ADDENDUM NO. 1 TO 18-0098-4

FOR: WILMINGTON ISLAND COMMUNITY CENTER WATER AND SEWER

PRE-BID QUESTIONS AND ANSWERS

Plan Revisions from Original Bid Set (revisions are clouded):

WILMINGTON ISLAND COMMUNITY BUILDING
125 WILMINGTON ISLAND ROAD
CHATHAM COUNTY, GEORGIA
FOR
THE CHATHAM COUNTY BOARD COMMISSIONERS
SITE PLAN AND FORCE MAIN PROFILE

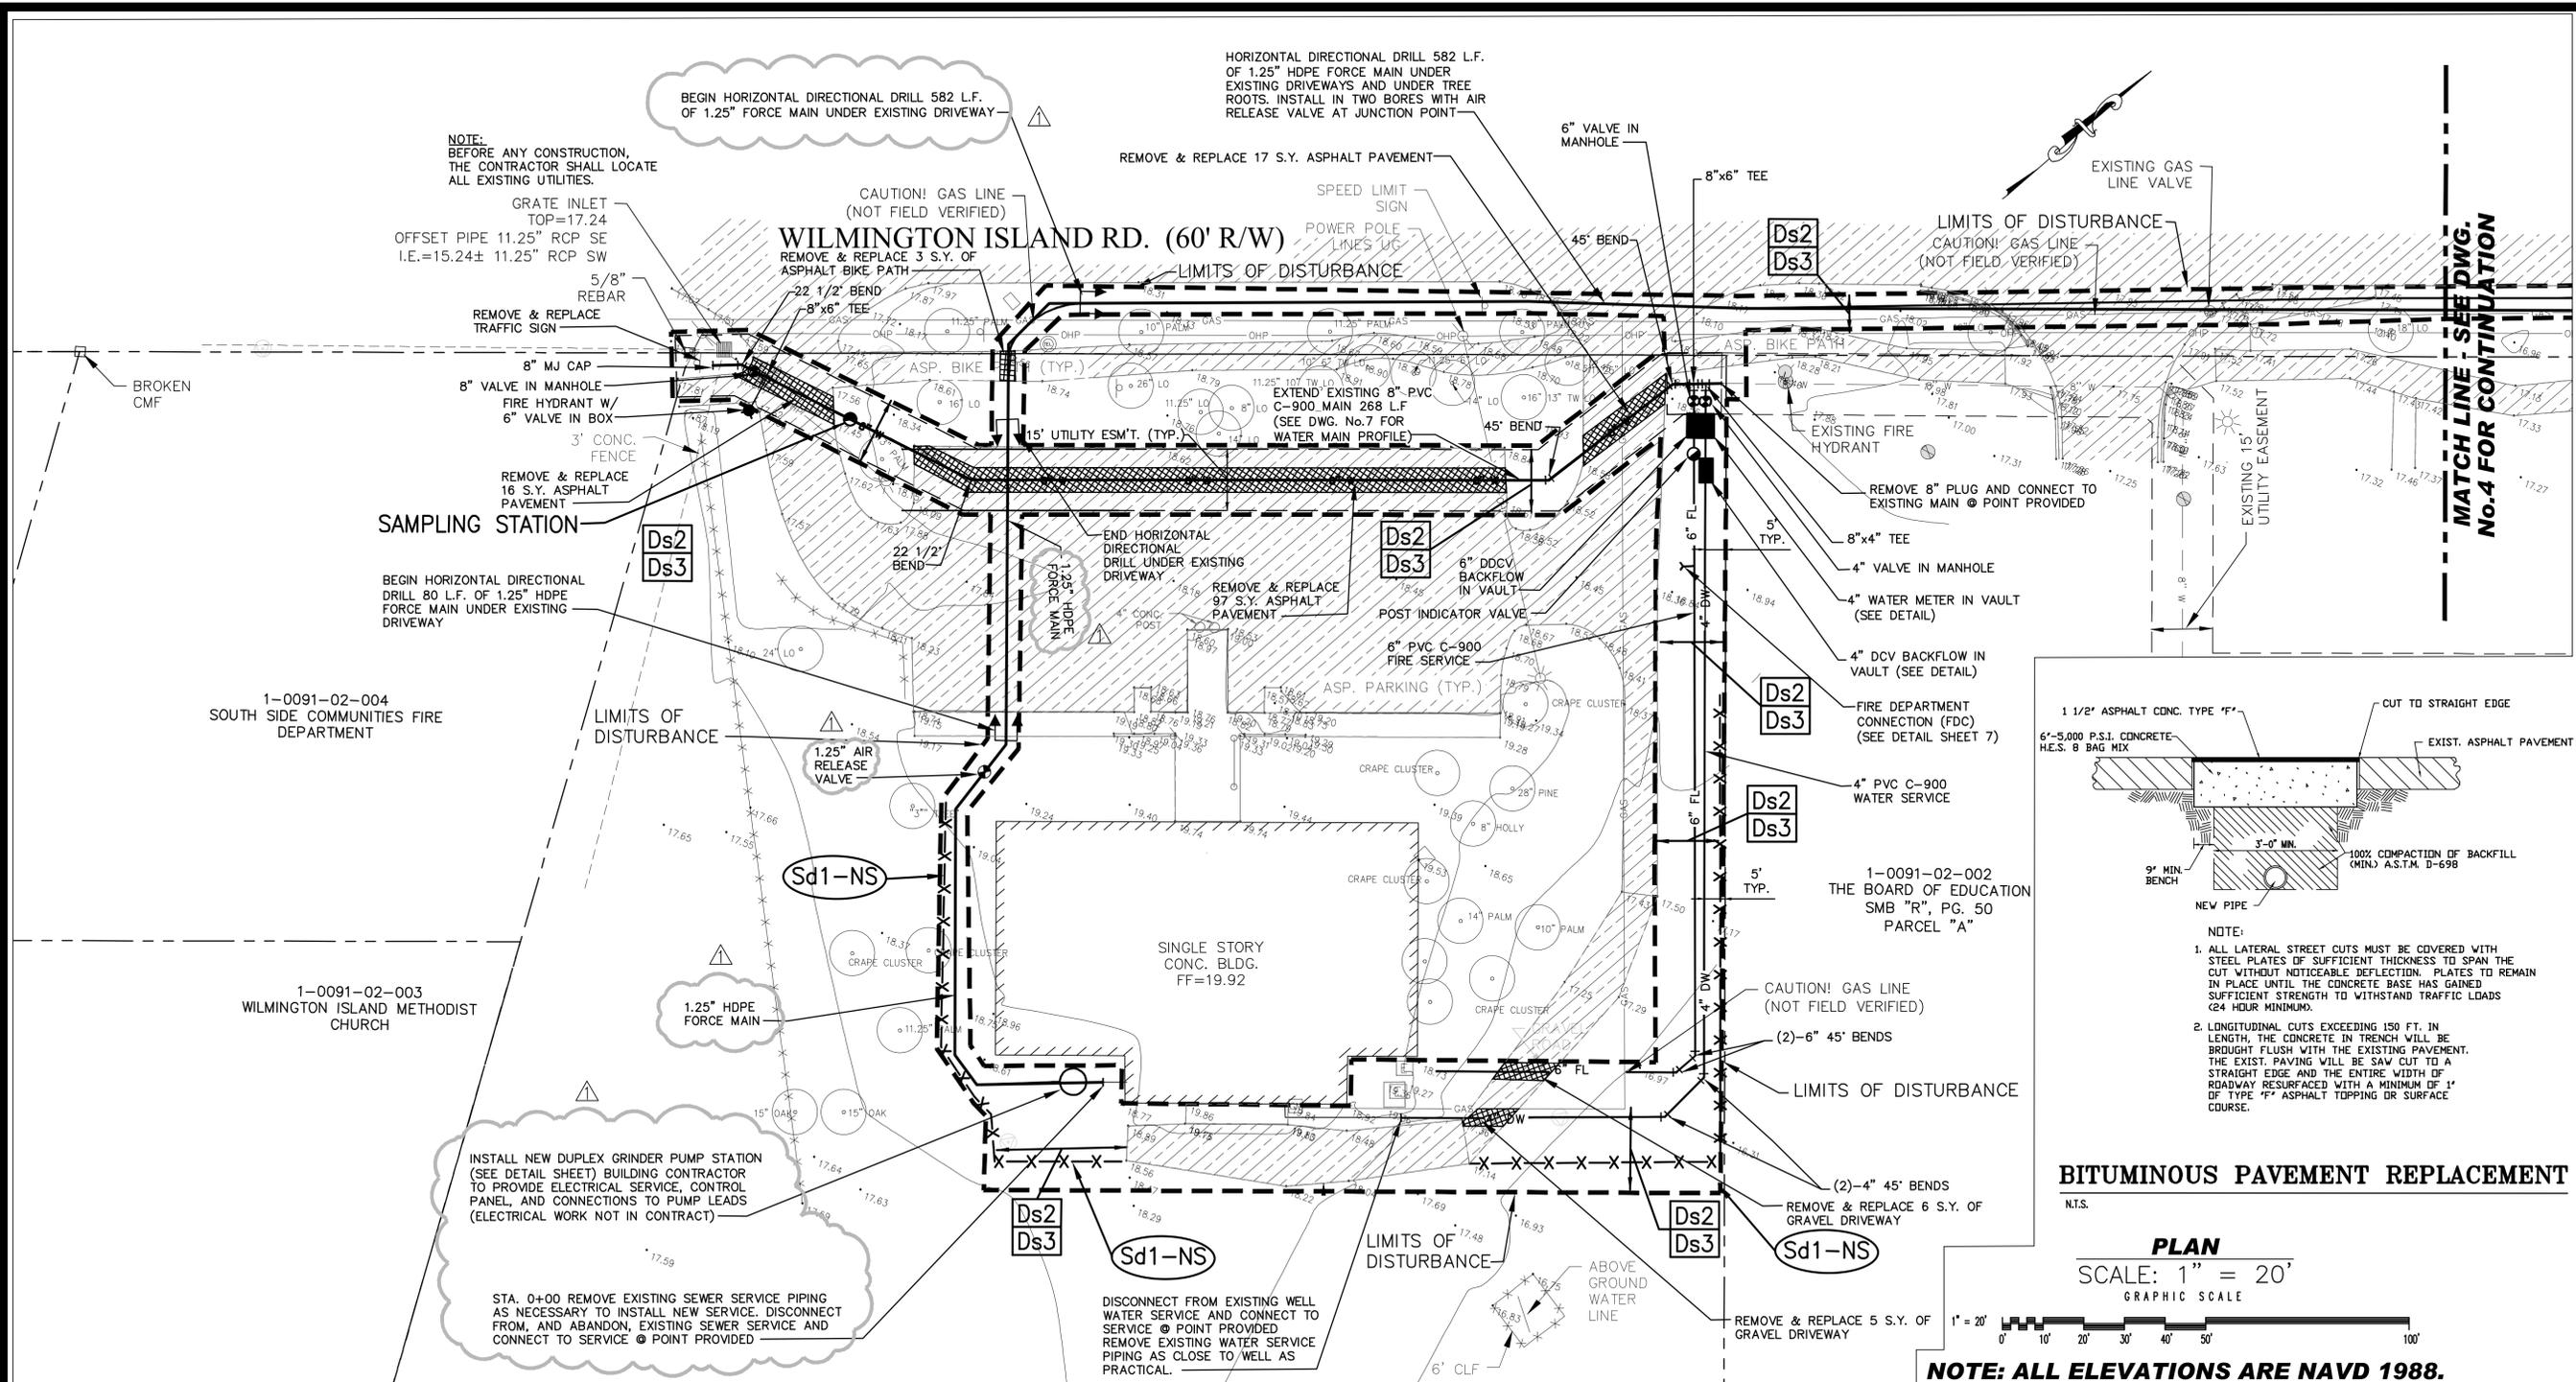
4. *Please clarify the note box on sheet 3 regarding the grinder pump station electrical service. Does this mean the building contractor will install the conduit and wire to our panel ? Or does it mean the building contractor will provide the proper breaker in the building panel ? If yes, to the later, will the building contractor already have a conduit stubbed out ?* This note has been revised for clarity, see plan sheet. The building contractor will be responsible for running the power to the pump panel, providing and installing the pump panel, and connecting the pump leads to the panel. No electrical work is included in this contract.

5. *Plan sheet 3 indicates the 4" meter vault and 6" BFP vault next to each other ? Are they to be one common vault or 2 separate vaults ? Is there sufficient space for the bypass of the meter in regard to the adjacent property line ?* Separate vaults. We believe there is sufficient room to install per plan and details, however the final dimensions of the enclosures and equipment shall be confirmed prior to installation and any conflicts reported to the County. If required, the enclosures could likely be staggered to provide additional room.

1. The notes on plan sheet 3 regarding the grinder pump, electrical scope, and existing service removal have been revised as noted in the question section.
2. The pump details on plan sheet 6 has been revised with additional information. The pump spec has been revised from 2.0 horsepower down to a 1.7 horsepower requirement. The pump discharge outlet has also been revised from 2" down to 1.25".
3. The force main diameter has been revised from 2" HDPE down to 1.25" HDPE (SDR 9, pressure class 200, AWWA C901 per City of Savannah spec for water services).

WILMINGTON ISLAND COMMUNITY BUILDING
125 WILMINGTON ISLAND ROAD
CHATHAM COUNTY, GEORGIA
FOR
THE CHATHAM COUNTY BOARD COMMISSIONERS
OFFSITE PLAN AND FORCE MAIN PROFILE

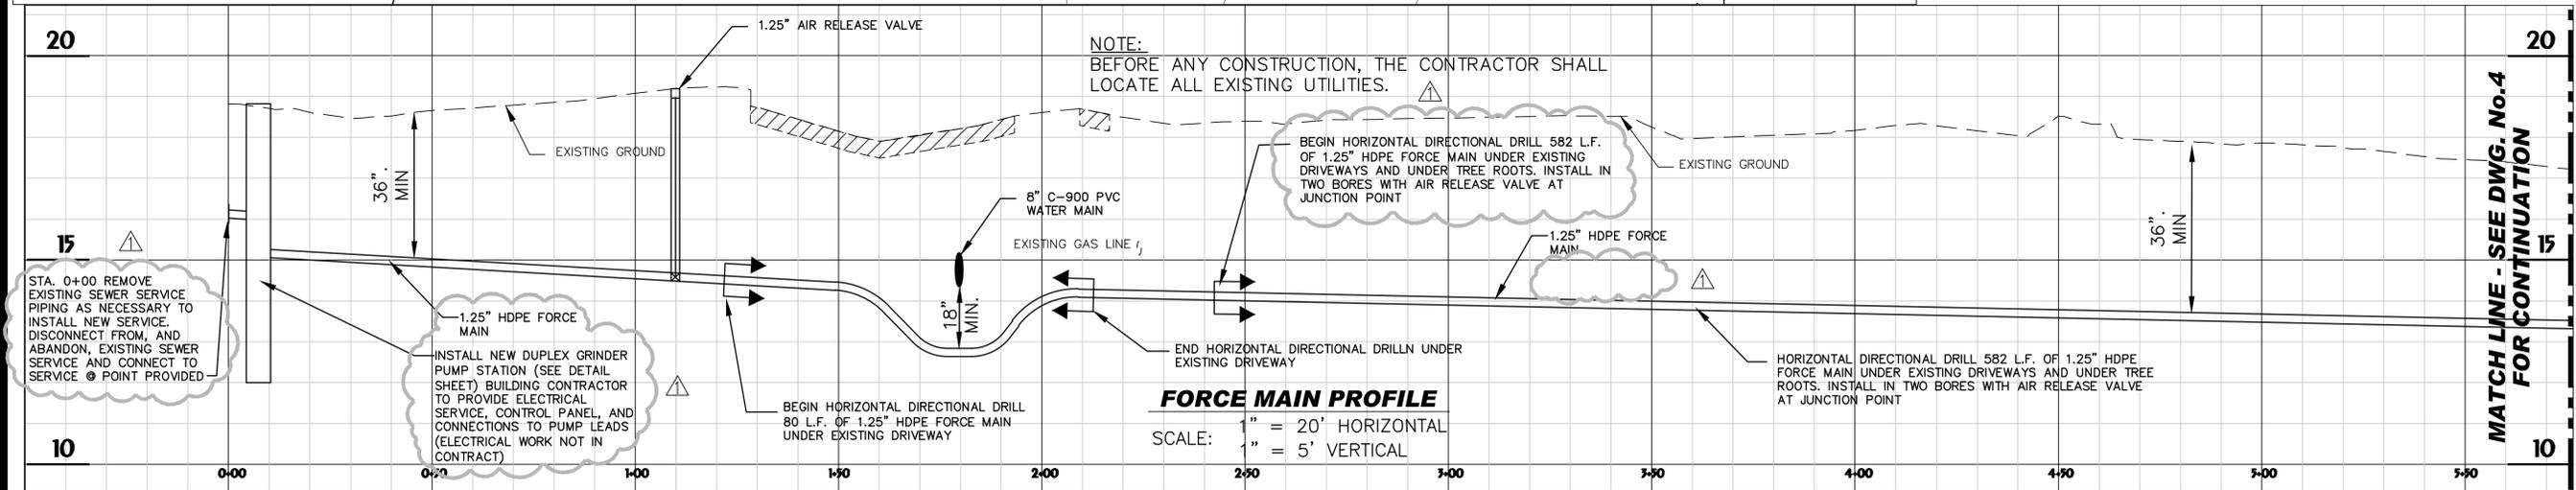
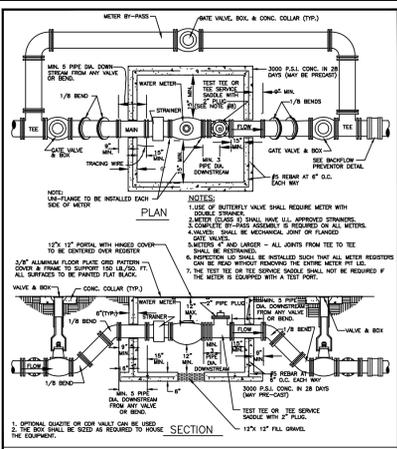
2. *Plan sheet 5 indicates to coat the receiving MH and one MH downstream per CoS spec. Plan sheet 6 provides CoS detail of receiving MHs which states to coat the receiving MH and the next 2. Please clarify the quantity of downstream MHs. Only the tie-in manhole and one manhole downstream require coating, this was confirmed during permitting.*

THE CONTRACTOR SHALL PROVIDE A
PROTECTIVE COATING ON THE RECEIVING
MANHOLE AND ONE MANHOLE DOWNSTREAM IN
ACCORDANCE WITH THE CITY OF SAVANNAH
SPECIFICATION SECTION 02555.
